RE: Staff Review Comments for 25 Monument Street – 5-unit condominium (2017-243) –
Planning Board Review

Project Name:	25 Monument Street	Project ID:	(2017-234)
Project Address:	25 Monument Street	CBL:	338-K-004
Applicant:	Monument Partners, LLC		
Planner:	Matthew Grooms

Subject: R-6 Small Infill & Multi-family Design Review – 25 Monument Street

1/29/18 R6 Design Review
25 Monument Street - prelim
Caitlin Cameron, Matt Croning, Jeff Levine

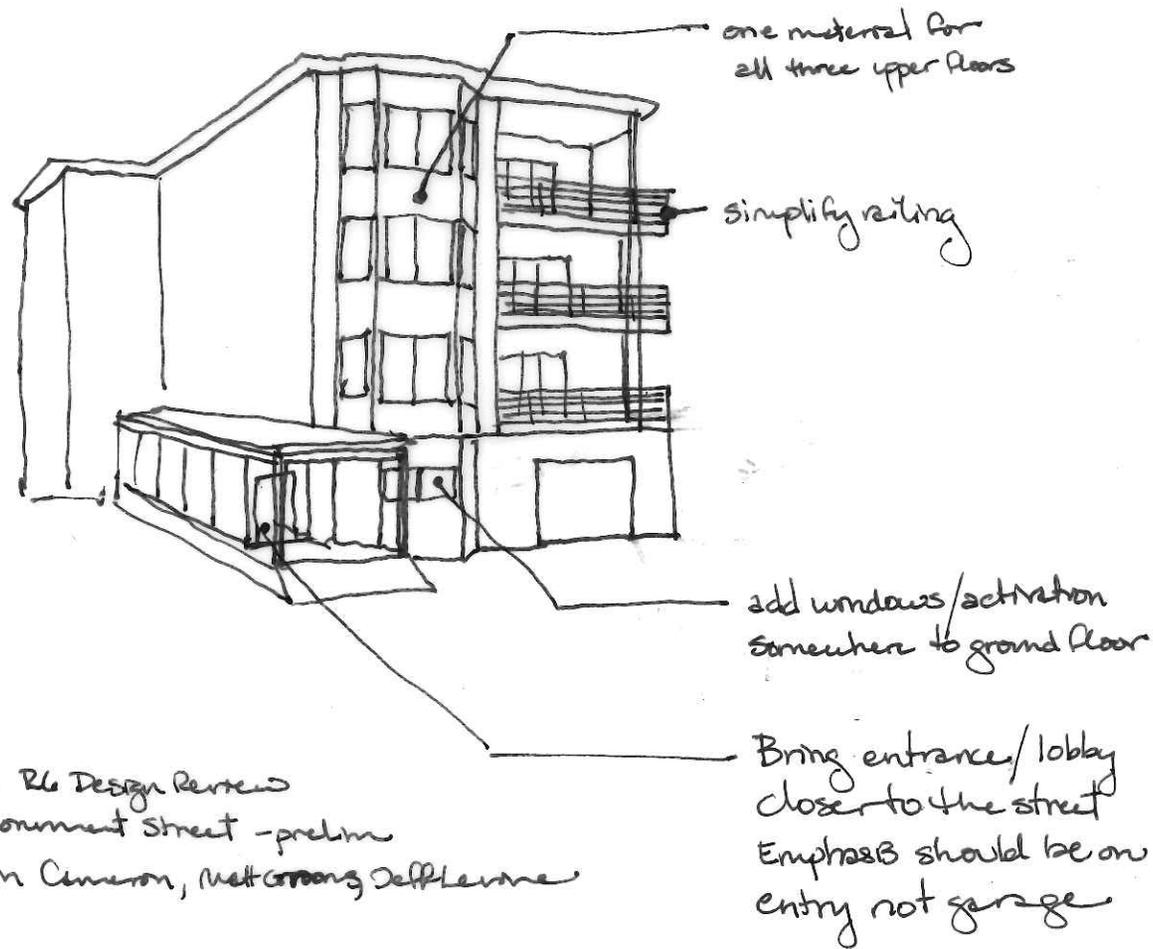
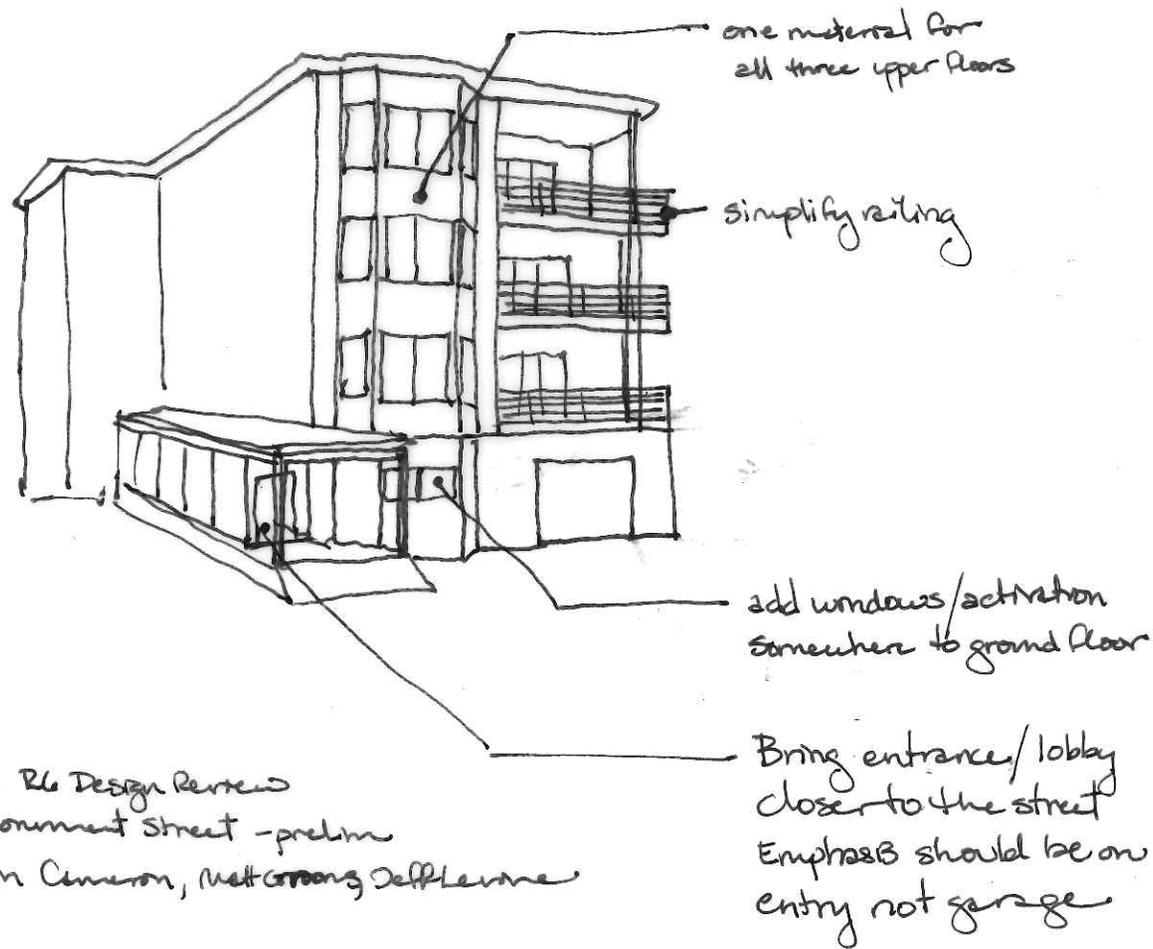
Principle F Articulation – Partially Met – The project employs several articulation methods to create visually interesting facades. **However, the number and placement of materials creates a busy façade and is inconsistent with the character of the context.**

- **F-1 Articulation:** Project employs a cornice, expression lines, materials with texture and scale, and porch details that provide shadow lines. **Is there trim or corner boards? How will the corners be detailed?**
- **F-2 Window Types:** Two window types.

- *F-3 Visual Cohesion:* There are excessive variations in materials disrupting the visual cohesion, creating awkward proportions, creating a façade more complex and busy than found in the context. Two materials – the railing and the vertical shiplap - contribute to the busy character of the building and break the façade inappropriately for the building type and context. Staff suggest only one material orientation (vertical or horizontal) should be applied consistently through the upper floors. The railing should be simplified, taking cues from the neighboring character.

- *F-4 Delineation between Floors:* Floors are delineated with material changes and porches. The delineation between the third and fourth floors is excessive with the material change.

- *F-5 Porches, etc.:* The porches are well integrated into the massing of the building. However, the design of the railing does not meet the standard – the style is overly complex, not integrated into the overall building character or the character found in context. In addition, the design of the entry porch feels boxy and lacking detail compared with the rest of the building. The cornice profile for that porch roof is adding to the heaviness of that design.

- *F-6 Main Entries:* The main entry is set back from the street – **emphasis should be on the entry rather than the garage door.** Staff suggest bringing the enclosed entry closer to the street, aligned with the front façade and activated the ground floor by using the bay as lobby space. Porch width may need to be revised to accommodate this.

- *F-7 Articulation Elements:* Project includes a cornice projecting at least 6”; there does not appear to be trim or corner boards; offsets meet 12” minimum; pronounced cornice.

Principle G Materials – Partially Met - The dominant neighborhood materials are small-scale residential choices such as clapboard, shingle, and brick. **There is an excessive number of materials – the predominant context is that of simplicity.**

- *G-1 Materials:* Clapboard and brick are in keeping with the residential context. **Vertical orientation of siding is less common.**
- *G-2 Material and Façade Design:* The brick at the ground floor with clapboard above is an appropriate placement according to their nature. **The bay does not need a difference material orientation to be effective as an articulation/massing element.**
- *G-3 Chimneys:* Not applicable
- *G-4 Window Types:* Two window types used.
- *G-5 Patios and Plazas:* Landscape plan indicates concrete pavers.
